SUNDRY NOTICES AND REPORTS ON WELLS
Do not use this form for proposals to drill or to re-enter an abandoned well. Use form 3160-3 (APD) for such proposals.

8. Well Name and No.
FEDERAL 19 1

9. API Well No.
30-025-24676-00-S1

Permanent Abandonment of Federal Wells
Conditions of Approval (LPC Habitat)

(BEFORE PLUGGING)

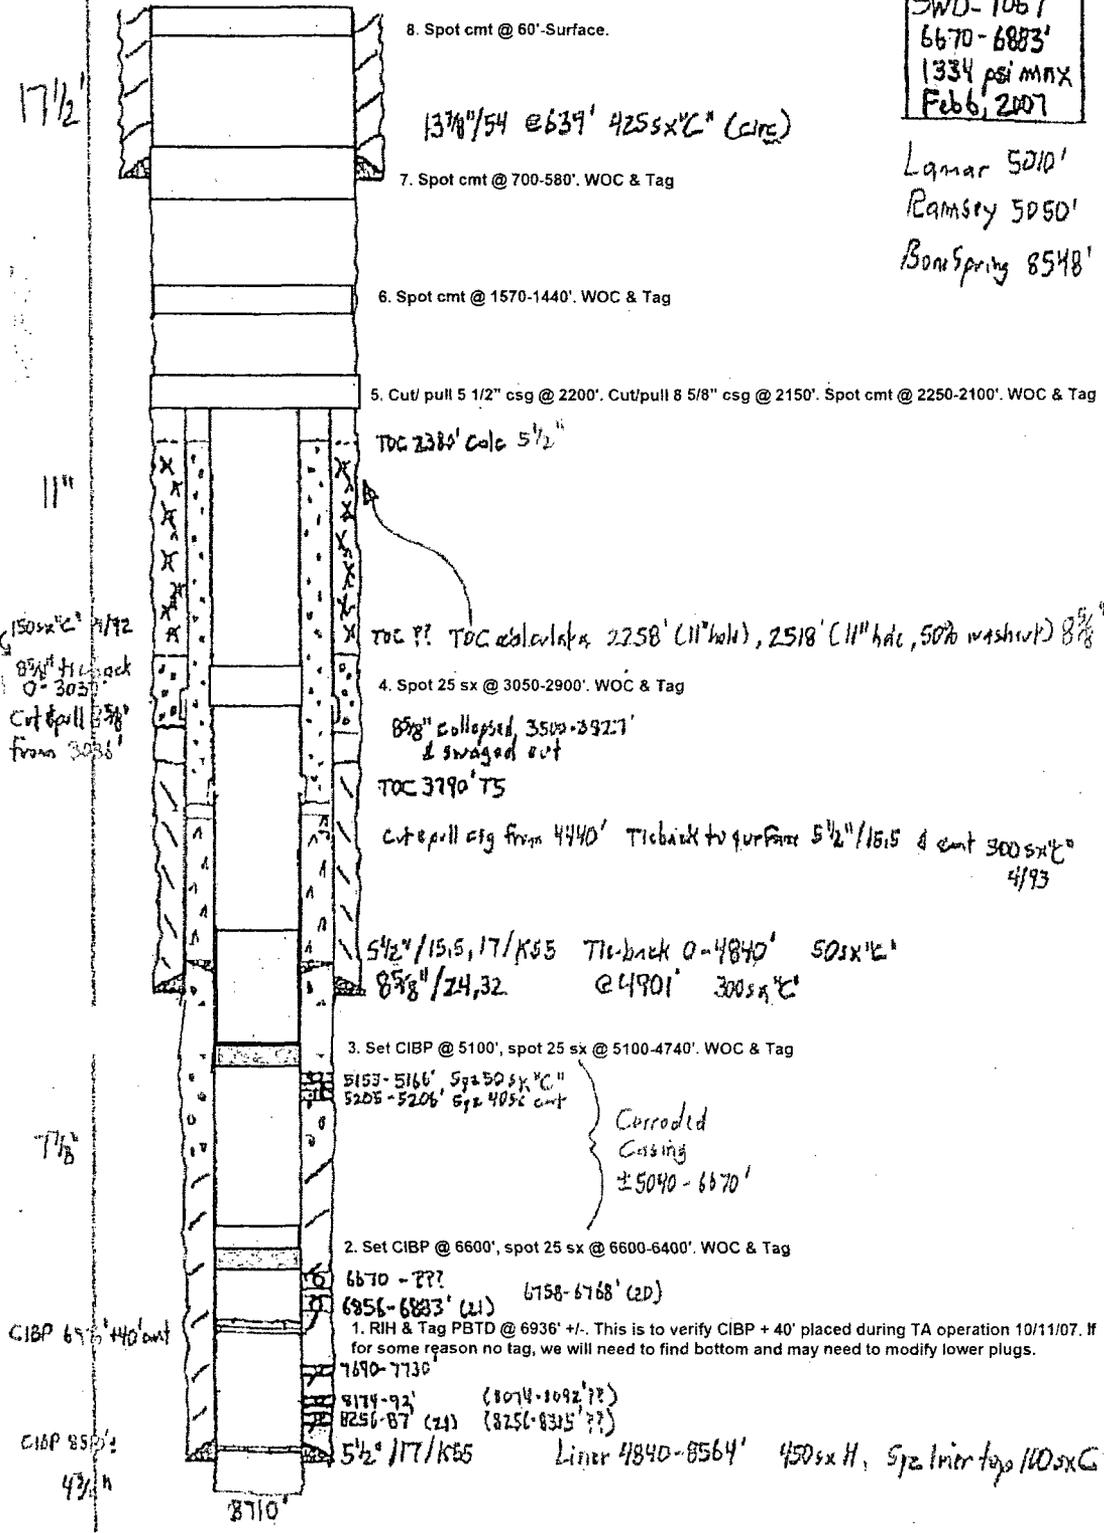
8. Spot cmt @ 60' Surface.

7. Spot cmt @ 700-580'. WOC & Tag

6. Spot cmt @ 1570-1440'. WOC & Tag

5. Cut/pull 5 1/2" csg @ 2200'. Cut/pull 8 5/8" csg @ 2150'. Spot cmt @ 2250-2100'. WOC & Tag

4. Spot 25 sx @ 3050-2900'. WOC & Tag

3. Set CIBP @ 5100', spot 25 sx @ 5100-4740'. WOC & Tag

2. Set CIBP @ 6600', spot 25 sx @ 6600-6400'. WOC & Tag

1. RIH & Tag PBTD @ 6936' +/- This is to verify CIBP + 40' placed during TA operation 10/11/07. If for some reason no tag, we will need to find bottom and may need to modify lower plugs.

Below ground level dry hole marker required
